## Addendum #1

Re: **Addendum No. 1**  
Cary Main EMS  
819 Kildaire Farm Road  
Cary, NC 27511  
ADW Job No. 21046  
Wake County Bid #24-086

These clarifications constitute Addendum No. 1 and considered part of the Bid Documents. General Contractor shall see that their sub-contractors are in full receipt of the information contained herein.

A002

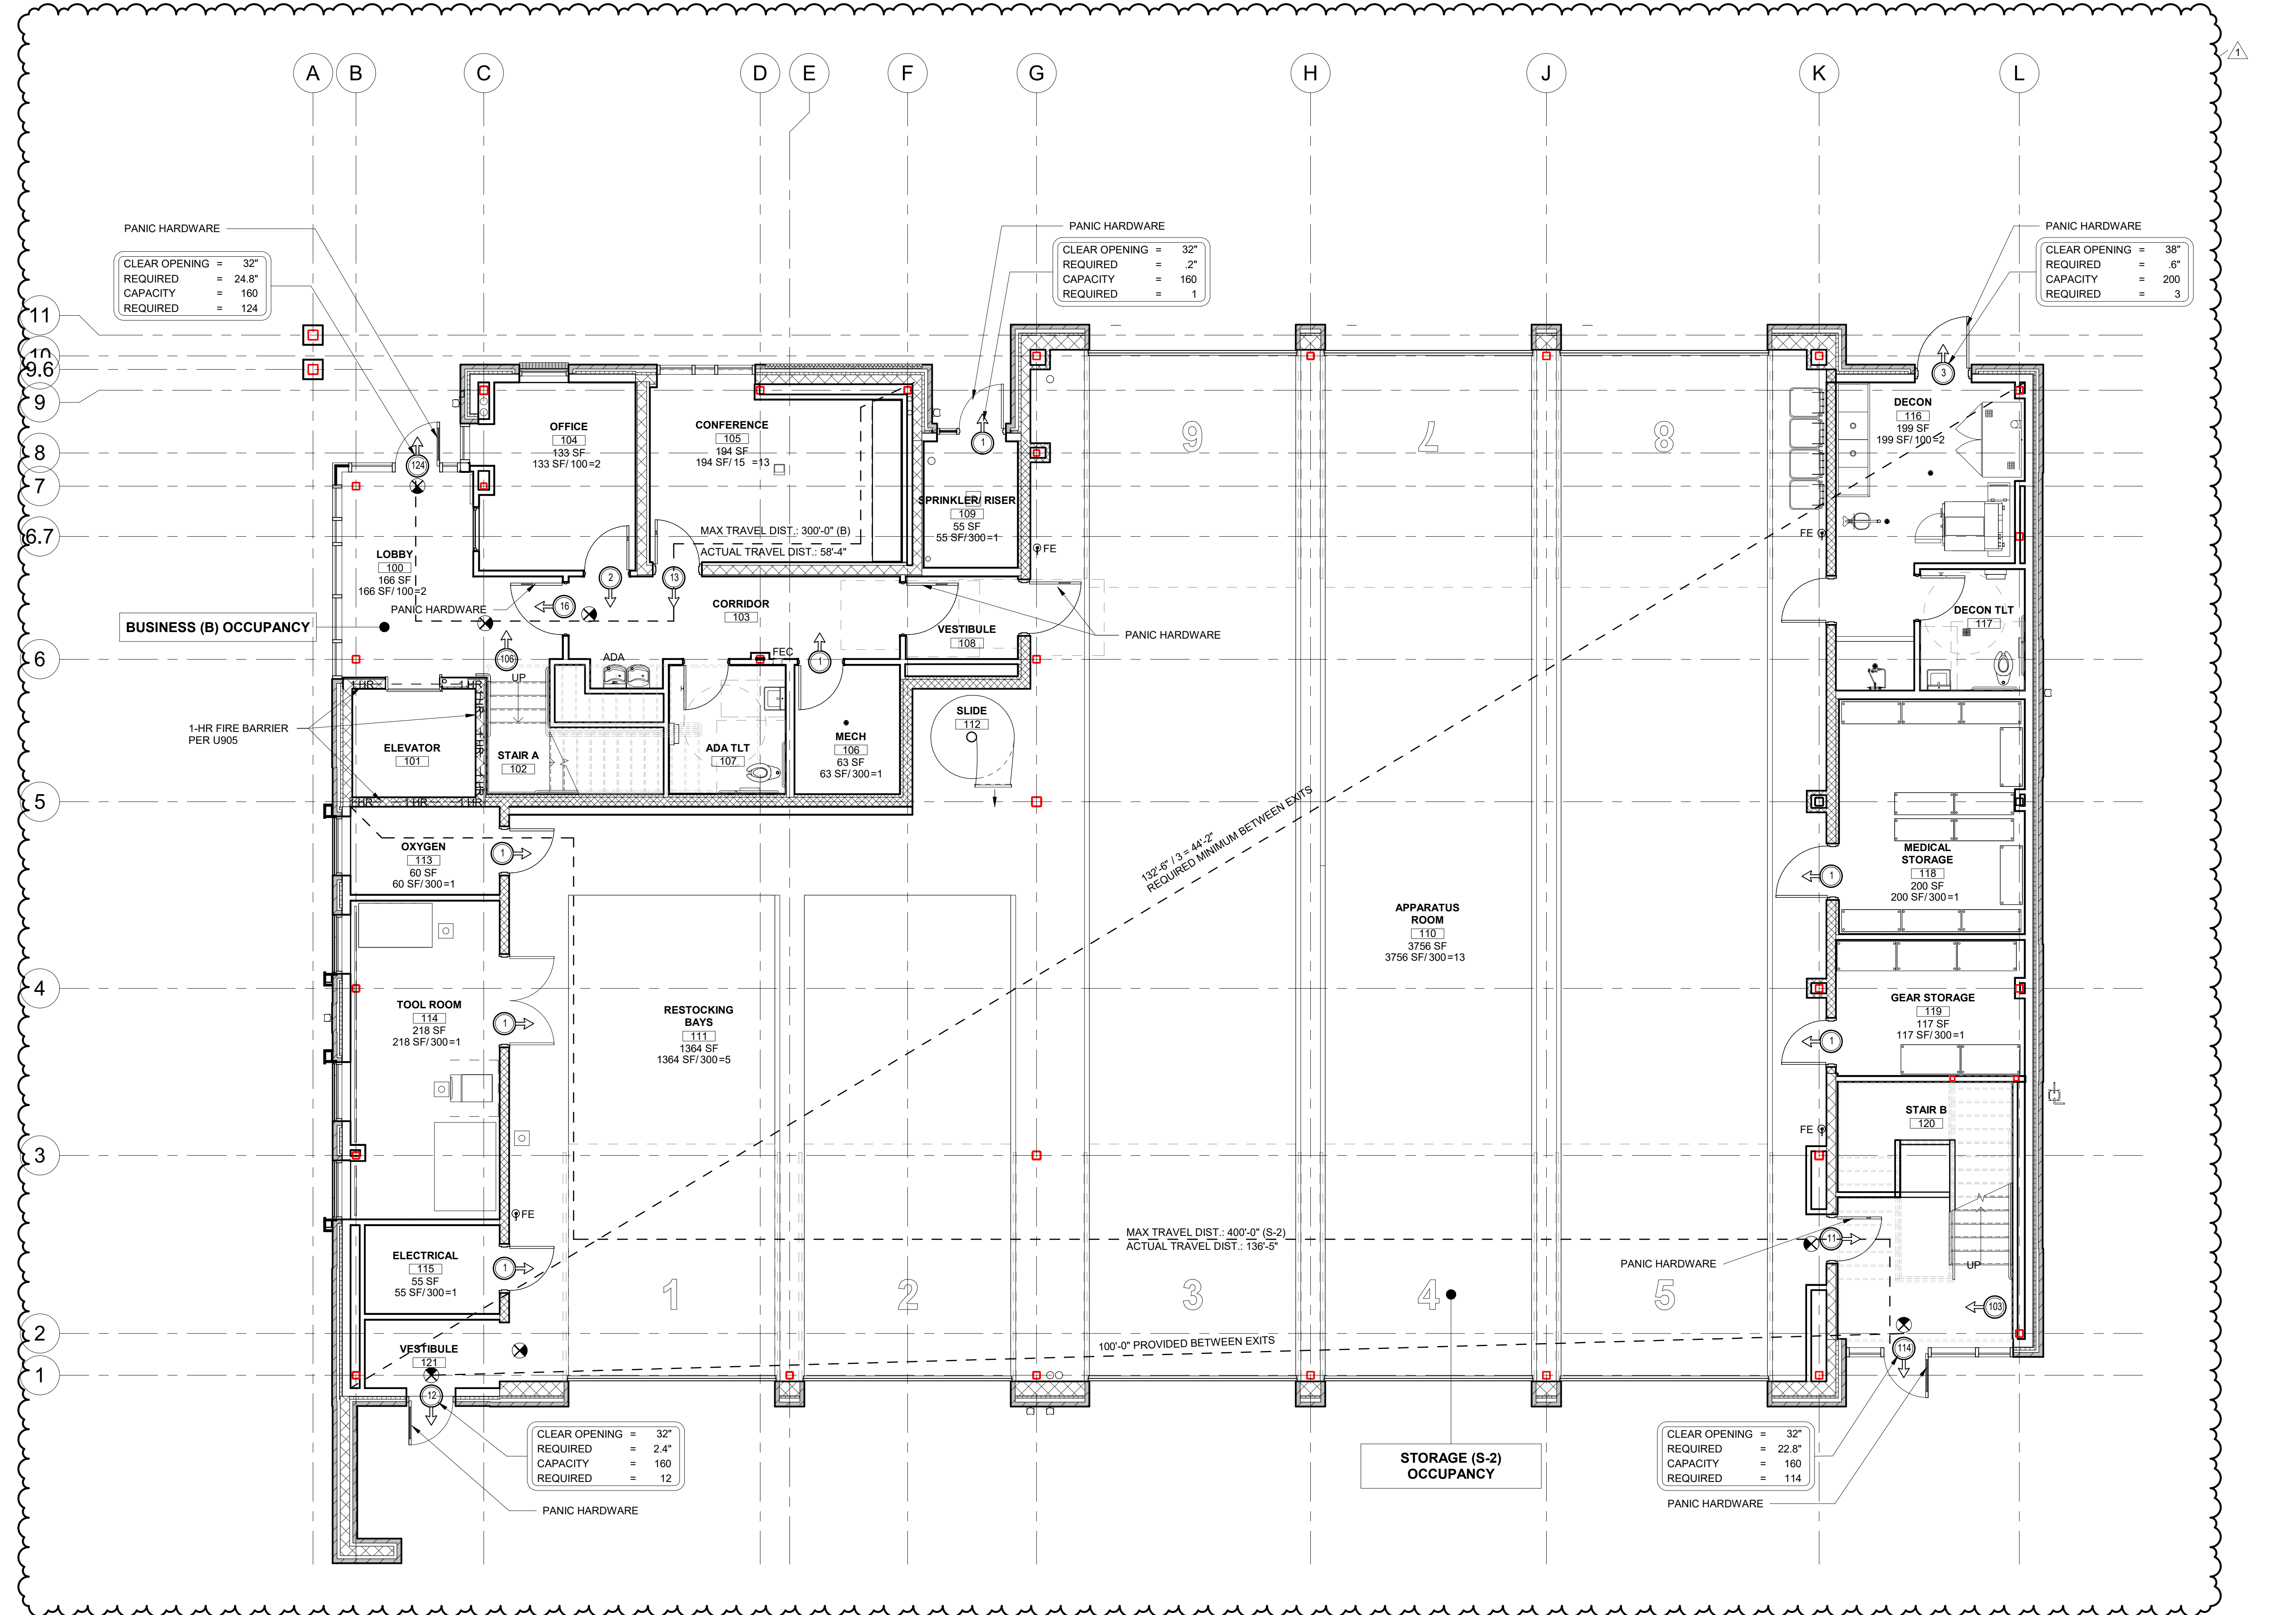
- 1.) See attached revised sheet A000-cover sheet. Sheet A006-UL details has been added to the bid set.
- 2.) See attached revised sheet A002-1<sup>st</sup> Floor Life Safety Plan. Doors with panic hardware were noted per permit review comments. Exit lights were added to this sheet per permit comments.

A003

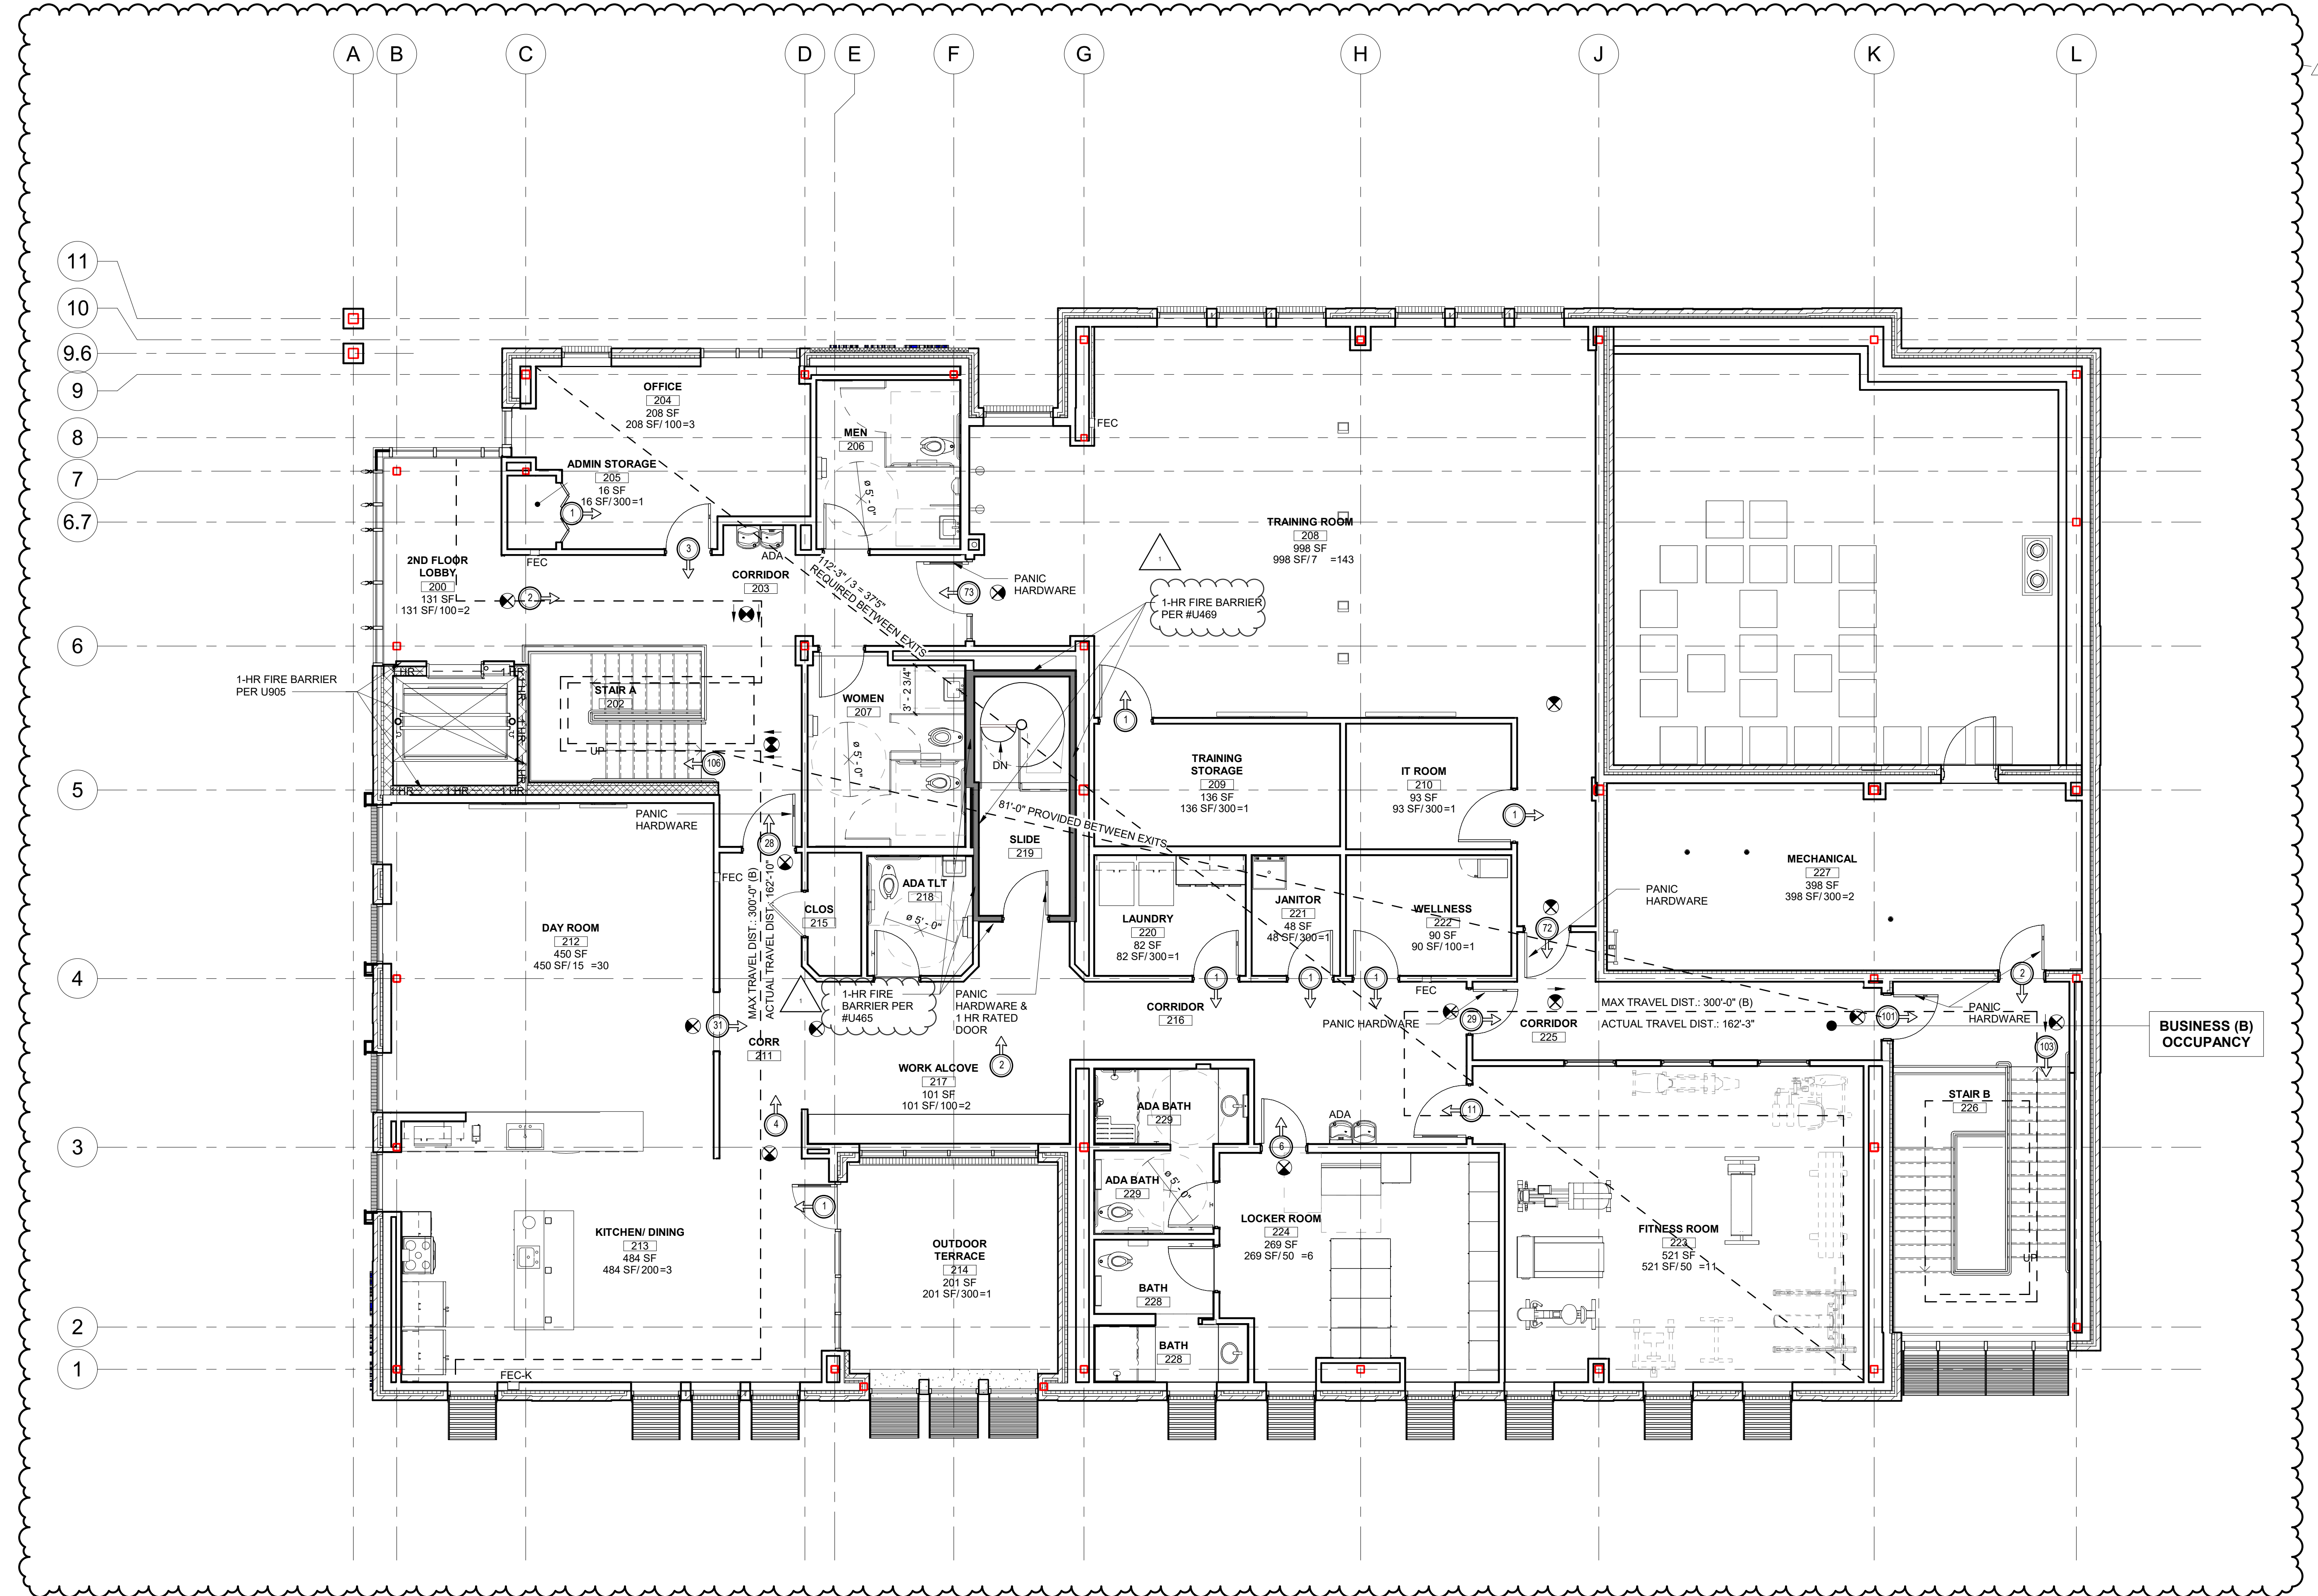
- 3.) See attached revised sheet A003-2<sup>nd</sup> floor Life Safety Plan. Doors with panic hardware were noted per permit review comments. Exit lights were added to this sheet per permit comments. Walls surrounding the slide 219 area were changed to 1-hr rated walls per permit comments.

**A004**

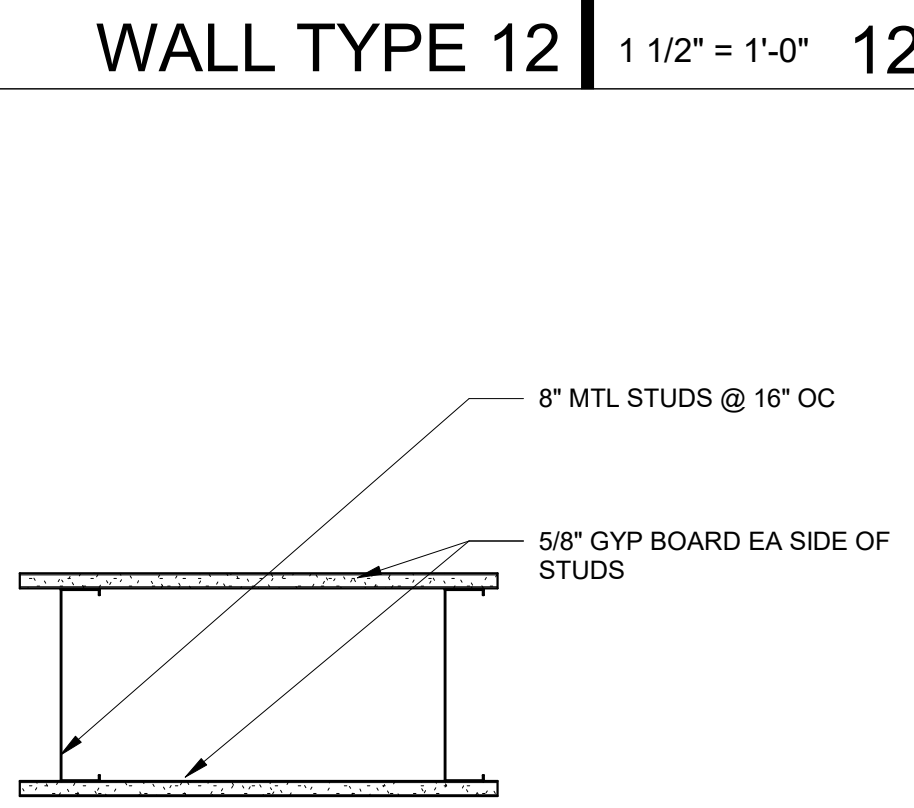
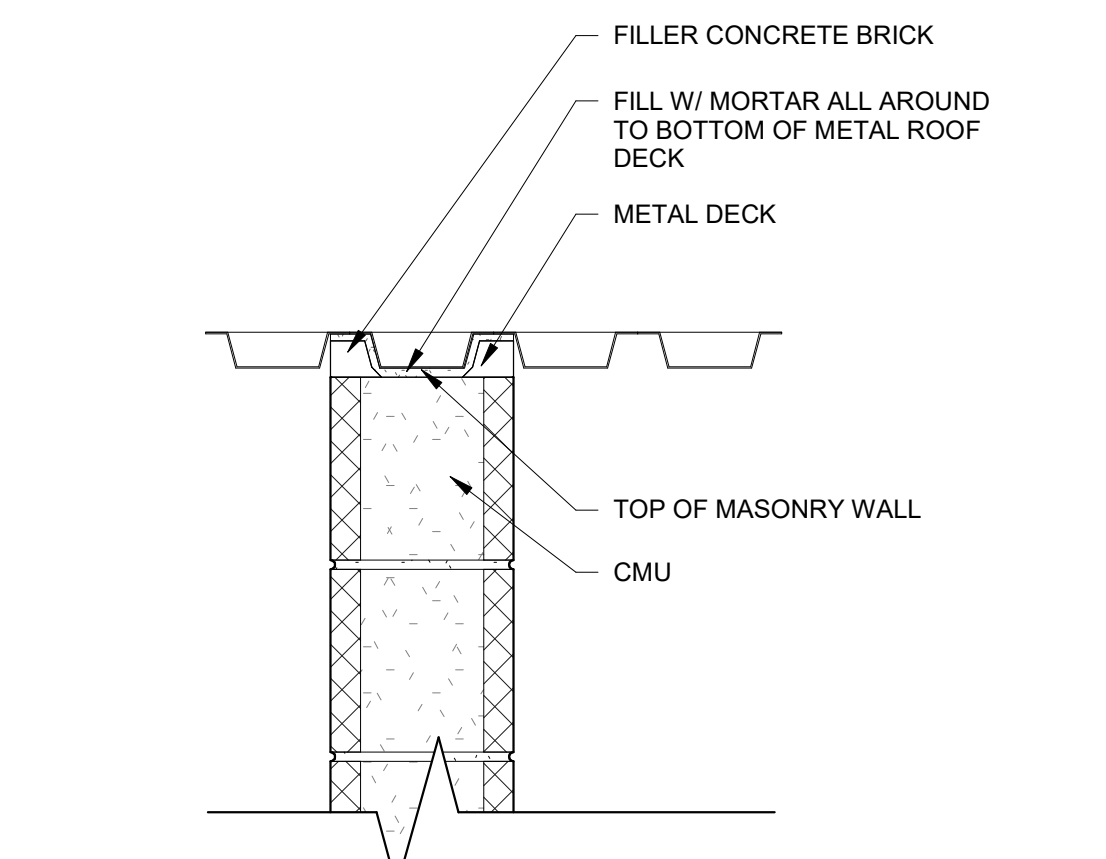
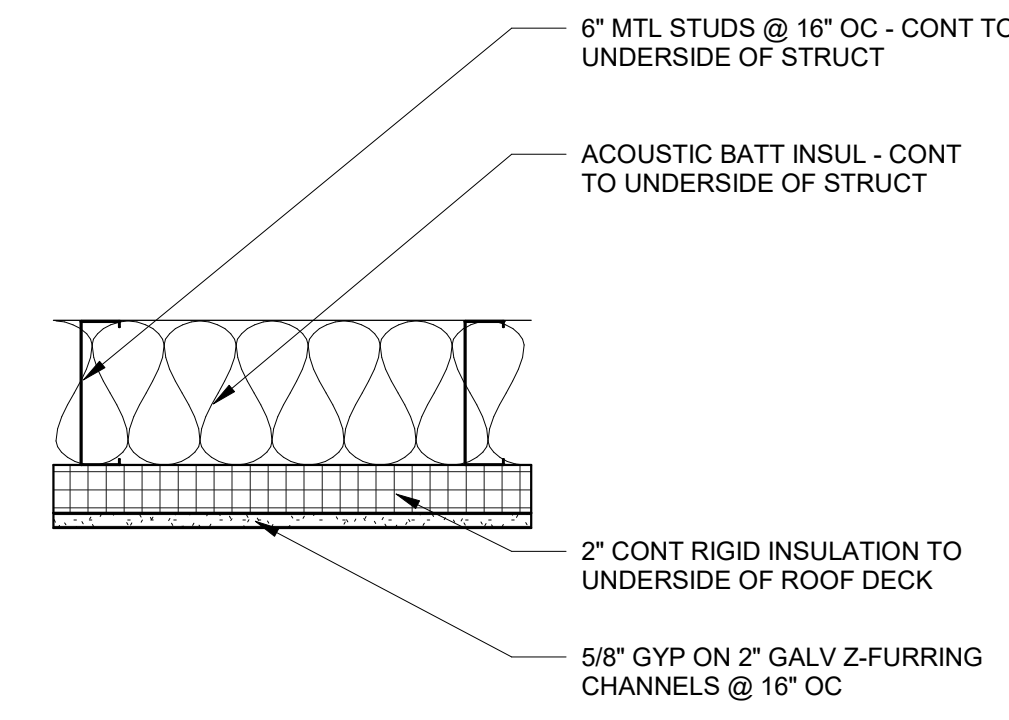
- 4.) See attached revised sheet A004-Wall types & UL details. Wall type #1C has been added for 1-hr UL detail U465. Wall type #15 has been added for 1-hr rated shaft wall.
